The Commission has issued the enclosed Amendments Nos. 27, 27, and 29 for Licenses Nos. DPR-38, DPR-47, and DPR-55 for the Oconee Nuclear Station, Units Nos. 1, 2, and 3. These amendments consist of changes to the Technical Specifications and are in response to your requests dated February 25, 1975, as revised May 7, 1976, and dated June 11, 1976.

AMENDMENT TO FACILITY OPERATING LICENSE

ATTACHMENT TO LICENSE AMENDMENTS

Revise Appendix A as follows:

FIGURE 2.1-1B

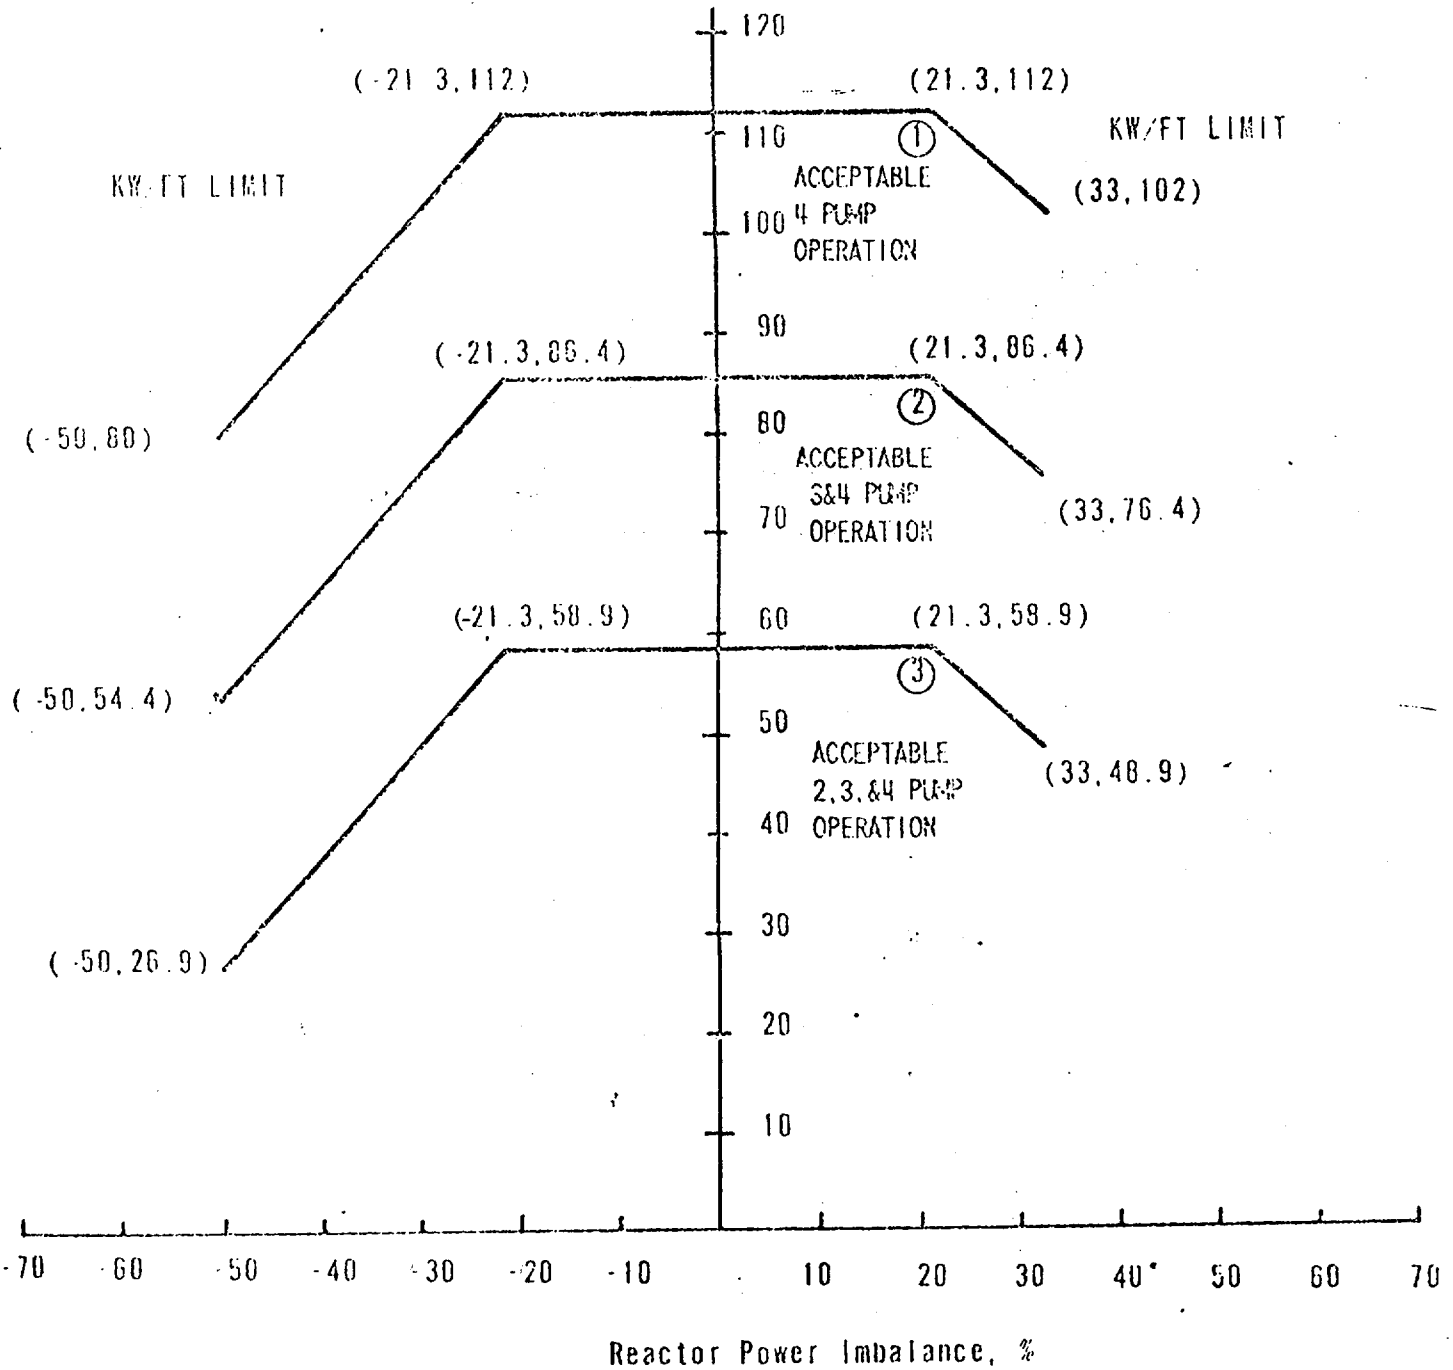
The curve presented in Figure 2.1-1B represents the conditions at which a minimum DNBR of 1.30 is predicted for the maximum possible thermal power (112 percent) when four reactor coolant pumps are operating (minimum reactor coolant flow is 141.3×10^6 lbs/hr). This curve is based on the following nuclear power peaking factors with potential fuel densification and fuel rod bowing effects: $F_q^N = 2.67$; $F_{\Delta H}^N = 1.78$; $F_z^N = 1.50$. The design peaking combination results in a more conservative DNBR than any other power shape that exists during normal operation.

The curve of Figure 2.1-1B is the most restrictive of all possible reactor coolant pump-maximum thermal power combinations shown in Figure 2.1-3B.

CORE PROTECTION SAFETY LIMITS
 UNIT 2
 OCONEE NUCLEAR STATION
 Figure 2.1-2B

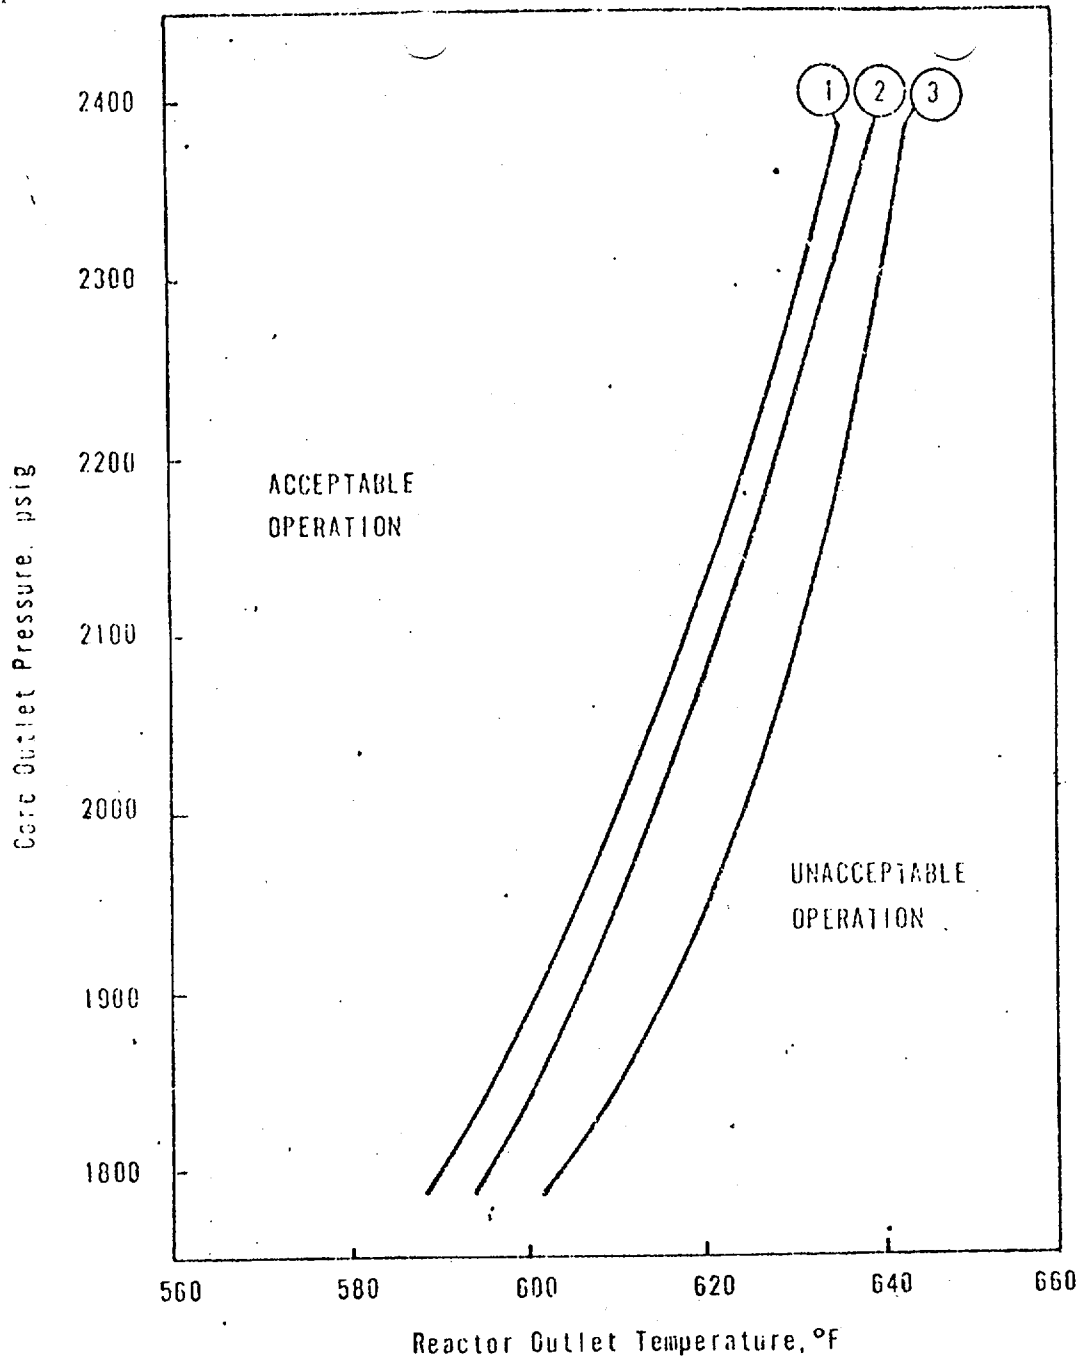
The curves of Figure 2.1-2B are based on the more restrictive of two thermal limits and include the effects of potential fuel densification and fuel rod bowing:

1. The 1.30 DNBR limit produced by a nuclear peaking factor of $F^N = 2.67$ or the combination of the radial peak, axial peak and position of the axial peak that yields no less than a 1.30 DNBR.
2. The combination of radial and axial peak that causes central fuel melting at the hot spot. The limit is 19.8 kw/ft for Unit 2.

The specified flow rates for Curves 1, 2, and 3 of Figure 2.1-2B correspond to the expected minimum flow rates with four pumps, three pumps, and one pump in each loop, respectively.

FIGURE 2.3-1B

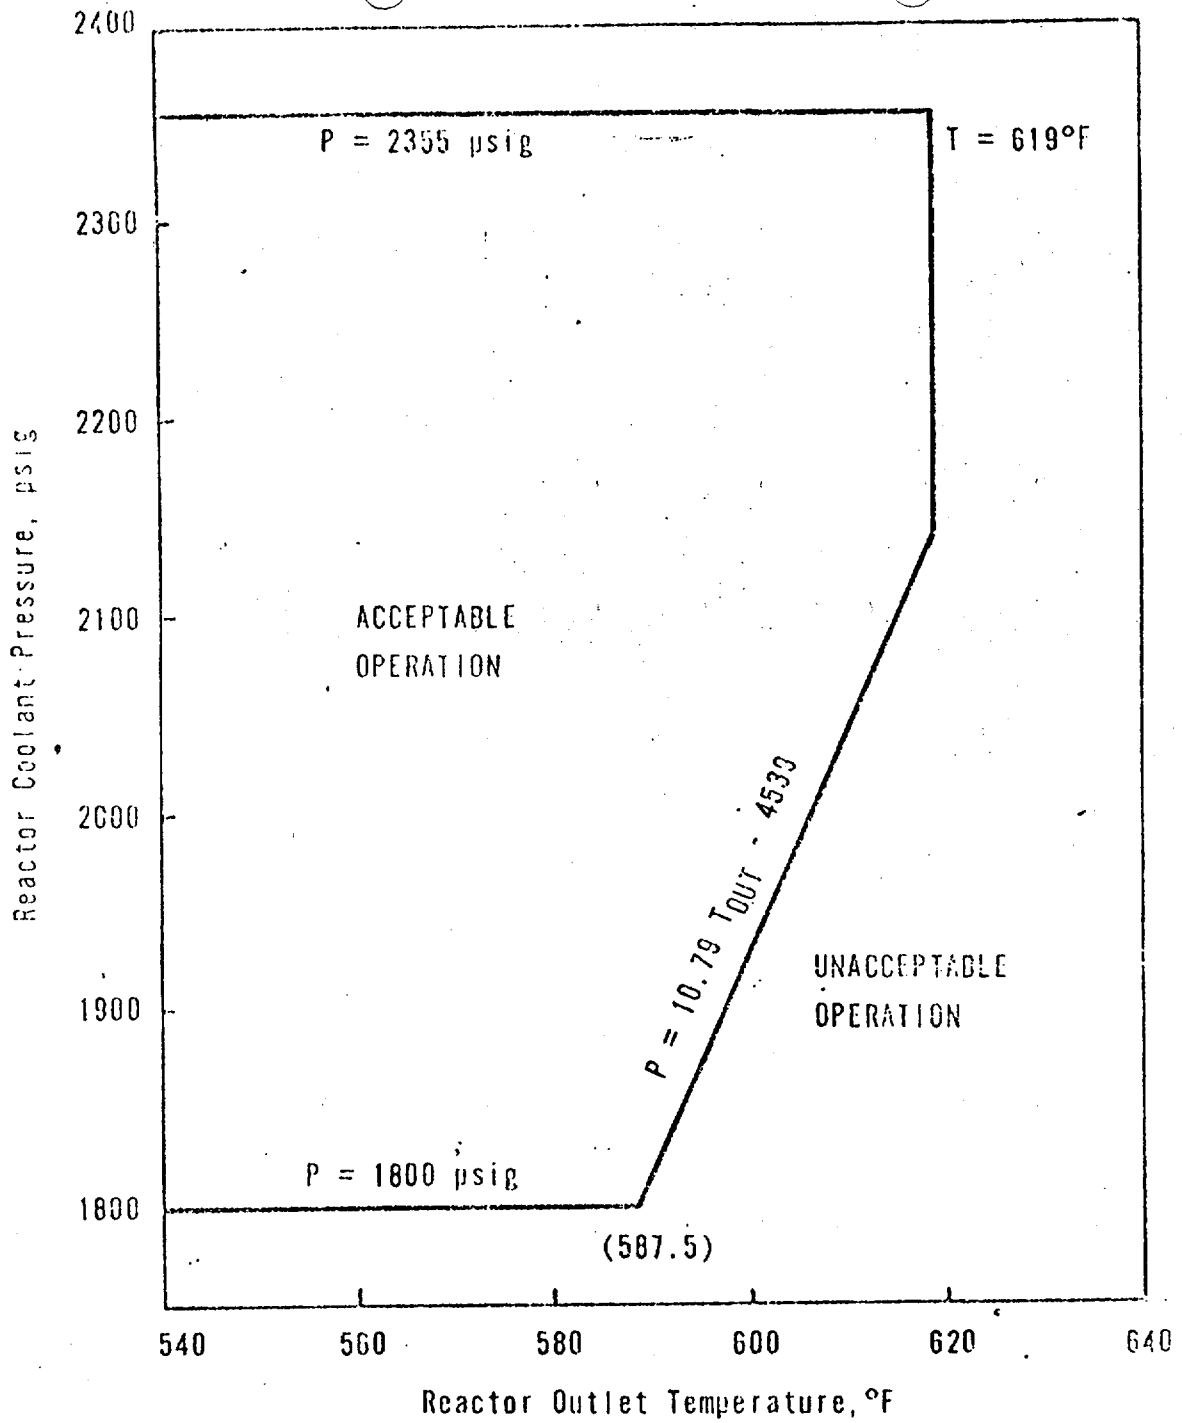
During a startup accident from low power or a slow rod withdrawal from high power, the system high pressure set point is reached before the nuclear over-power trip set point. The trip setting limit shown in Figure 2.3-1A - Unit 1

2.3-1B - Unit 2

for high reactor coolant system pressure (2355 psig) has been established to maintain the system pressure below the safety limit (2750 psig) for any design transient. (1)

FIGURE 2.3-2B

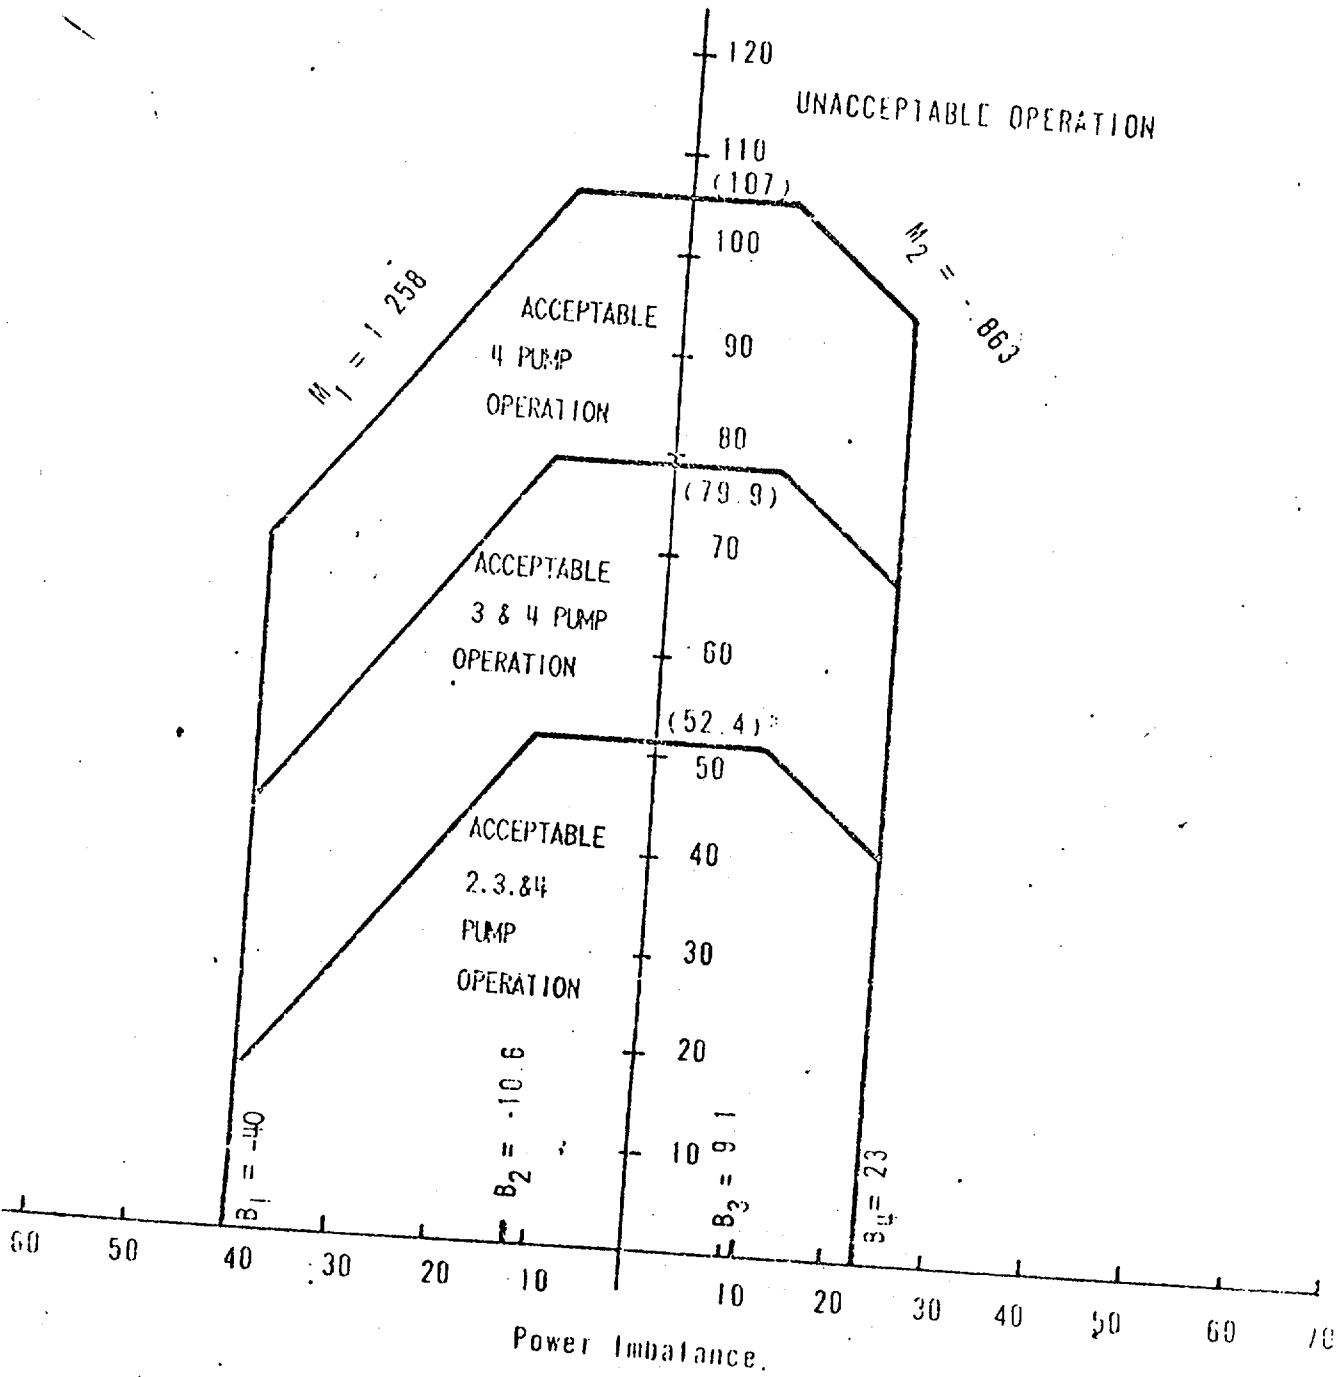
The power-imbalance boundaries are established in order to prevent reactor thermal limits from being exceeded. These thermal limits are either power peaking kw/ft limits or DNBR limits. The reactor power imbalance (power in the top half of core minus power in the bottom half of core) reduces the power level trip produced by the power-to-flow ratio such that the boundaries of Figure 2.3-2A - Unit 1 are produced. The power-to-flow ratio reduces the power

- 2.3-2A - Unit 1
- 2.3-2B - Unit 2
- 2.3-2C - Unit 3

OPERATIONAL POWER IMBALANCE
ENVELOPE FOR OPERATION
FROM 0 TO 150±10 EFPD
UNIT 2
OCONEE NUCLEAR STATION
FIGURE 3.5.2-3B1

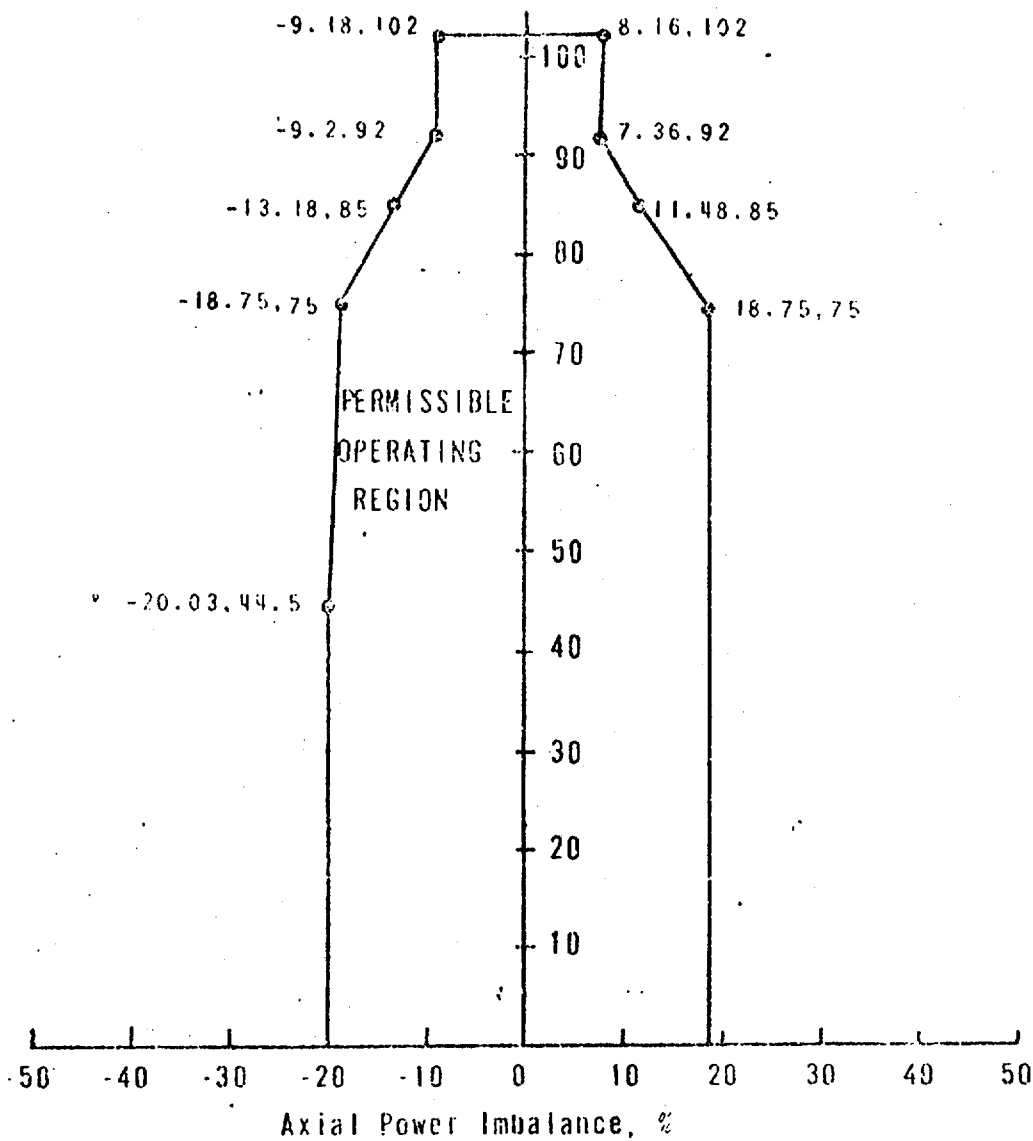
3.5.2.6 Reactor power imbalance shall be monitored on a frequency not to exceed two hours during power operation above 40 percent rated power. Except for physics tests, imbalance shall be maintained within the envelope defined by Figures 3.5.2-3A1, 3.5.2-3A2, 3.5.2-3B1, 3.5.2-3B2, 3.5.2-3B3, and 3.5.2-3C. If the imbalance is not within the envelope defined by Figure 3.5.2-3A1, 3.5.2-3A2, 3.5.2-3B1, 3.5.2-3B2, 3.5.2-3B3, and 3.5.2-3C, corrective measures shall be taken to achieve an acceptable imbalance. If an acceptable imbalance is not achieved within two hours, reactor power shall be reduced until imbalance limits are met.

The power-imbalance envelope defined in Figures 3.5.2-3A1, 3.5.2-3A2, 3.5.2-3B1, 3.5.2-3B2, 3.5.2-3B3, and 3.5.2-3C is based on LOCA analyses which have defined the maximum linear heat rate (see Figure 3.5-2-4) such that the maximum clad temperature will not exceed the Final Acceptance Criteria. Corrective measures will be taken immediately should the indicated quadrant tilt, rod position, or imbalance be outside their specified boundary. Operation in a situation that would cause the Final Acceptance Criteria to be approached should a LOCA occur is highly improbable because all of the power distribution parameters (quadrant tilt, rod position, and imbalance) must be at their limits while simultaneously all other engineering and uncertainty factors are also at their limits.** Conservatism is introduced by application of:
